# UNITED STATES PATENT AND TRADEMARK OFFICE

APPLICATION NO.	FILING DATE	FIRST NAMED INVENTOR	ATTORNEY DOCKET NO.	CONFIRMATION NO.
10/036,982	12/31/2001	William E. Ryan JR.	F-423	5328
919	7590	06/22/2005	EXAMINER	
PITNEY BOWES INC.			RODRIGUEZ, JOSEPH C	
35 WATERVIEW DRIVE			ART UNIT	
P.O. BOX 3000			PAPER NUMBER	
MSC 26-22			3653	
SHELTON, CT 06484-8000			DATE MAILED: 06/22/2005

***Non-Final Rejection***

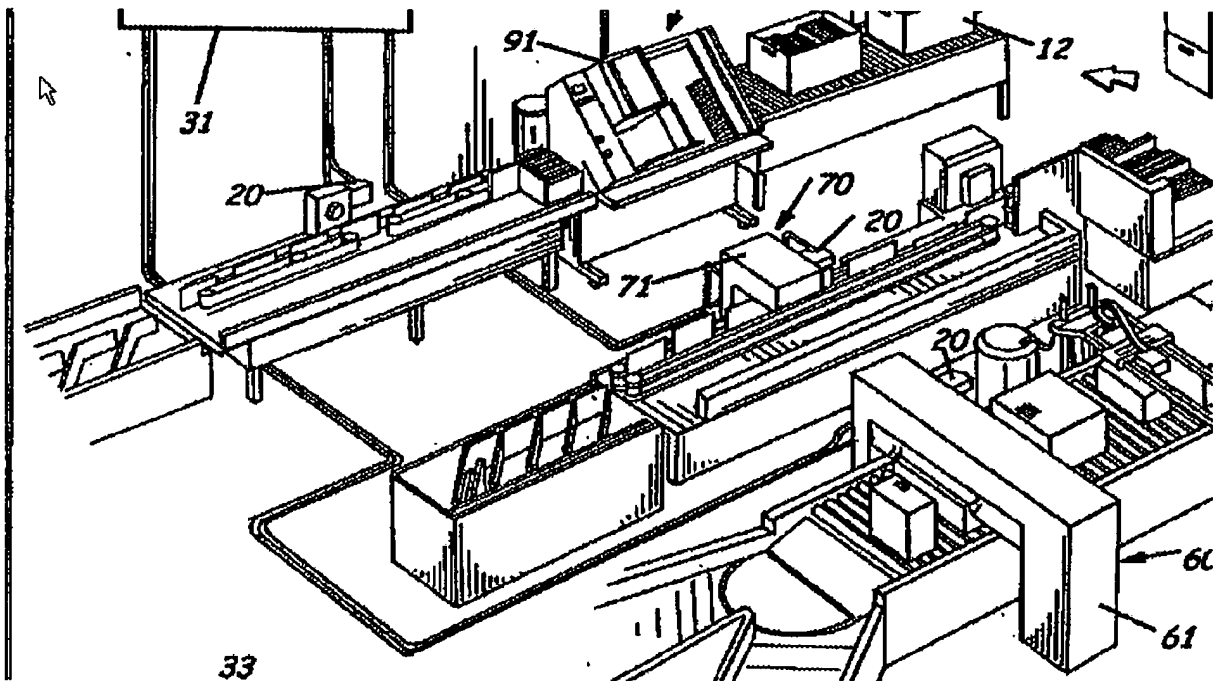
Regarding claims 3-9, Lopez teaches the detection module as claimed by Applicant (Fig. 4, near 20; para. 34, 44, 51). In particular, the excerpt from figure 4 included below clearly shows a first and second set of driven belts, which can also be regarded as guide walls, creating a feed path with a gap in front of the first letters and flats detection apparatus (near 20 in upper left corner).

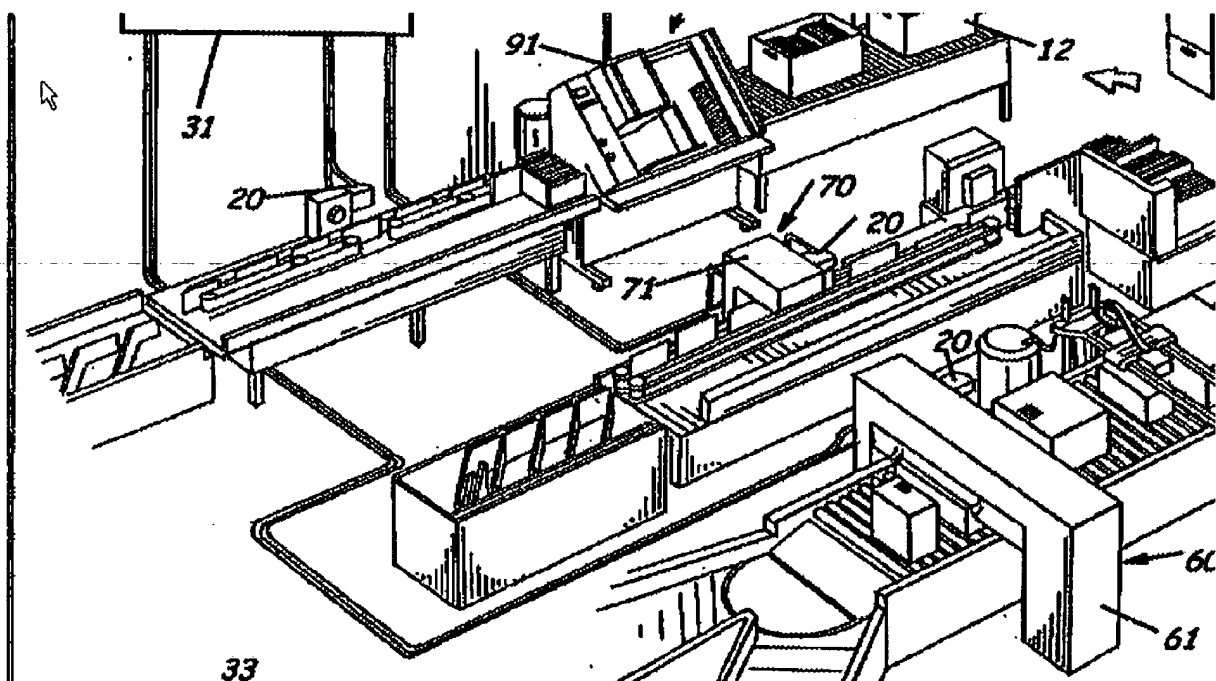
Applicant's additional argument that the combination of Call and Lopez fails to teach or suggest "determining a destination bin that is further used to expedite mail processing" is also misplaced. This limitation is not even part of claims 1 or 2 as Applicant merely claims determining a destination bin. Moreover, Lopez expressly teaches determining a destination bin (Fig. 1, near 108, 112 and Fig 4, as excerpted below, partition bins near end of letters and flats conveyors).
